HENDY WIND FARM: Land Off A44 SW Of Llandegley Llandrindod Wells Powys

Application for discharge of condition 23 from P/2014/0672 (APP/T6850/A/17/3176128):SWMP

Hendy Windfarm Development Hydrological Impacts

Figure 1. The wind turbine locations shown in red, background map OS 1:25,000 sheet 200.

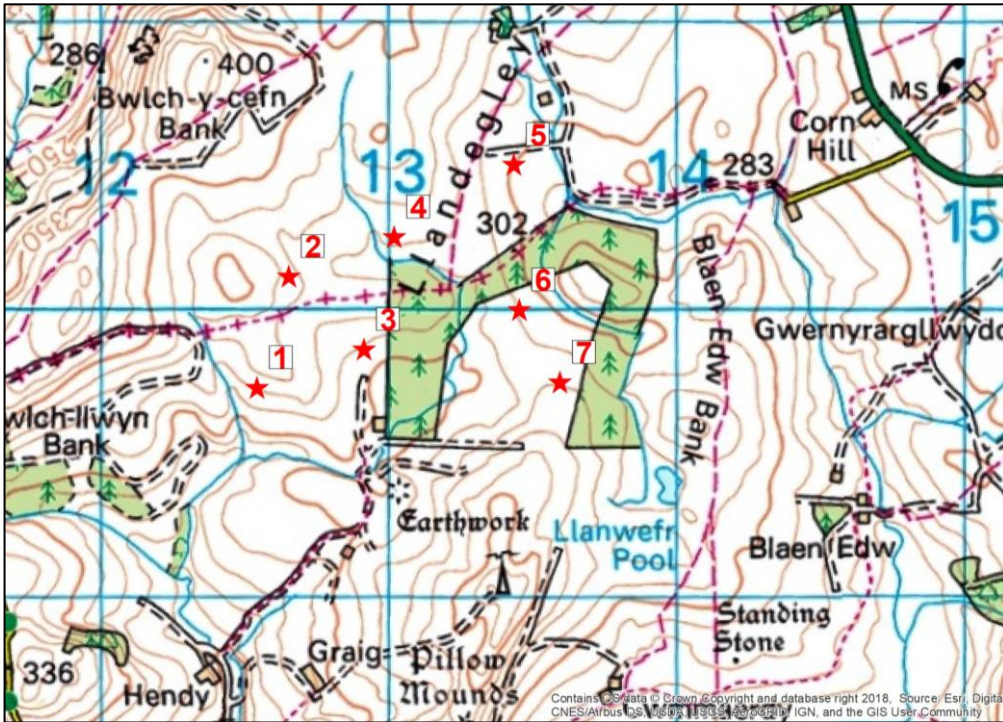
The location of the seven turbine sites are shown in Figure 1. A visit to the site on 11th January 2019 confirmed that the development is an upland area of steep to rolling topography with rough grazing, moorland and forestry, as shown in Figure 2. The area includes the upper reaches of the River Edw (Figure 3) and the Nant Brook - both tributaries of the River Wye which has been designated as a Special Area of Conservation. The visit also confirmed that work had begun on Turbine number 5, the most northerly of the sites which was viewed from the byway open to all traffic in Figure 4. This shows the extent of excavations at the site and the amount of bare soil which has been uncovered.

A proper consideration of mitigation features also needs to be included. It appears that much of the text describing mitigation in the SWMP is simply generic, and in many cases does not consider if these are appropriate for the type of the development and the setting within the landscape. For example, the use of swales is proposed for turbine bases, tracks, compound, sub-station and crane pad construction mitigation. Swales are described in detail in the current SUDS guidelines and are shallow ditches with a 1 in 4 side-slope which are included in designs not to convey water but to collect water from impermeable surfaces and allow the gradual infiltration into the soil/groundwater or loss through evapotranspiration. The swales are described as having a maximum depth of water as 0.3m. To comply with the 1 in 4 side slope each side of the swale would need to cover a distance of 1.2m. Assuming a base of 1m, the total width would need to be 3.4m. The excavation of a swale along side the type of access tracks in the steep to rolling topography of the wind turbine site, such as that shown in Figure 1, would not be possible.

Figure 5. The 20m (yellow) and 50m (pink) buffer around waterways (blue) in the area of the wind turbine development site (red outline). Background map OS 1:10,000 open raster.

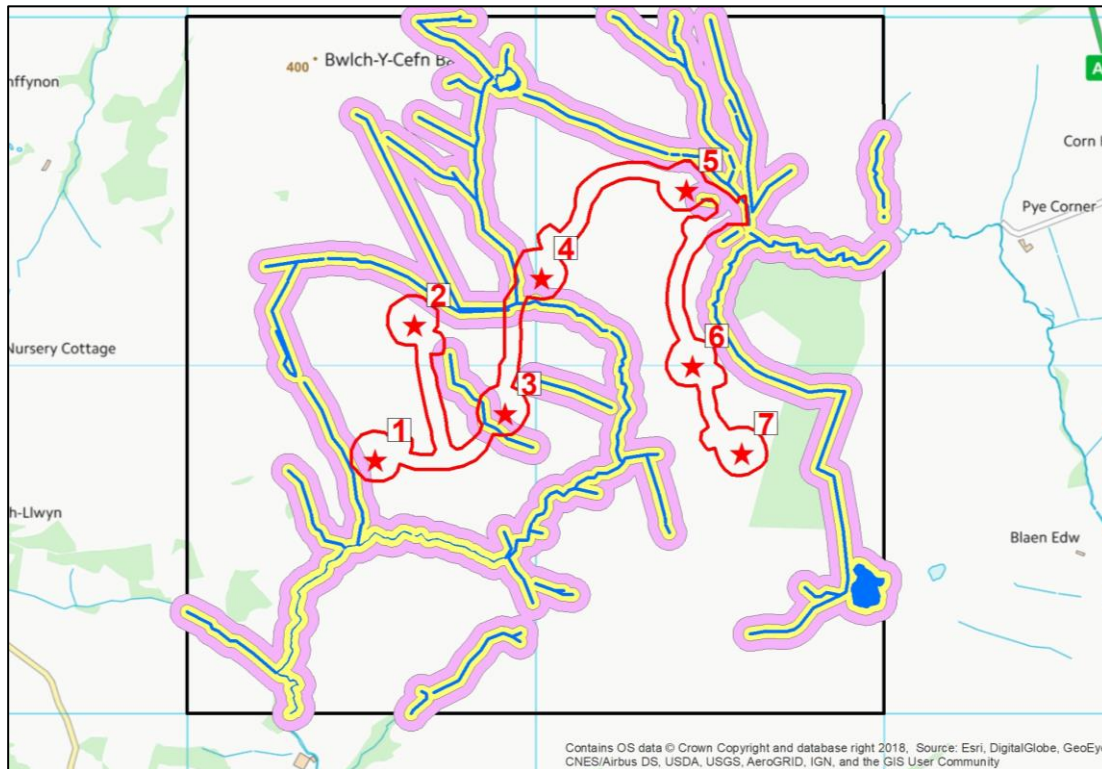
Other methods such as the use of GIS to produce maps and perform spatial analysis should have been demonstrated. For example, a common mitigation method mentioned throughout the SWMP (and ES) is the limiting of any construction work where possible to areas outside buffer from each waterway. The ES used a 20m buffer but the SWMP suggested a 50m buffer. Neither report provided any maps indicating the extent of these buffers in relation to the development area. Such mapping is a relatively straightforward exercise using GIS software. An example of these buffers for the 4km area surrounding the development site is shown in Figure 5.
